To: Development Permit Panel
From: Brian J. Jackson, MCIP
Director of Development
Date: January 11, 2010
File: DP 07-399354
Re: **Application by Ledingham McAllister Communities Ltd. for a Development Permit at 8600 Park Road (Formerly 6760, 6780, and 6800 Eckersley Road, 8500, 8520, and 8540 Park Road, 6751, 6760, 6771, 6780, 6791, 6800, and 6831 Park Place, and the Park Place Road Right-of-Way)**

Staff Report

SECTION THRU BALCONY AT PARK ROAD
SCALE: 1/4" = 1'-0"

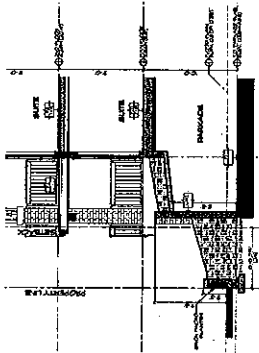
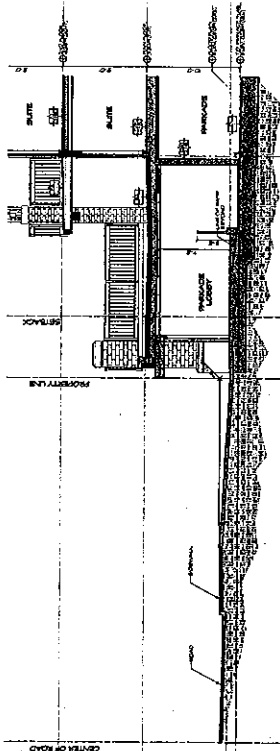
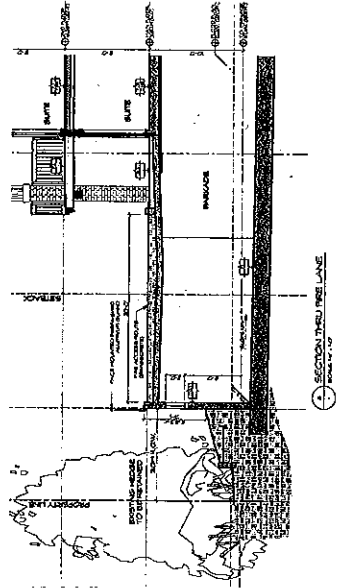
- 2) Increase the maximum allowable projection for unenclosed balconies projecting into a public road setback as follows:
 - i. From 1.2 m to 1.3 m on Eckersley Road; and
 - ii. From 2.1 m to 2.3 m on Park Road.

Staff support the proposed variance as the proposed increases in allowable projections are minor (i.e. 0.1 m on Eckersley Road and 0.2 m on Park Road) and will contribute to a more visually interesting, attractive streetscape.
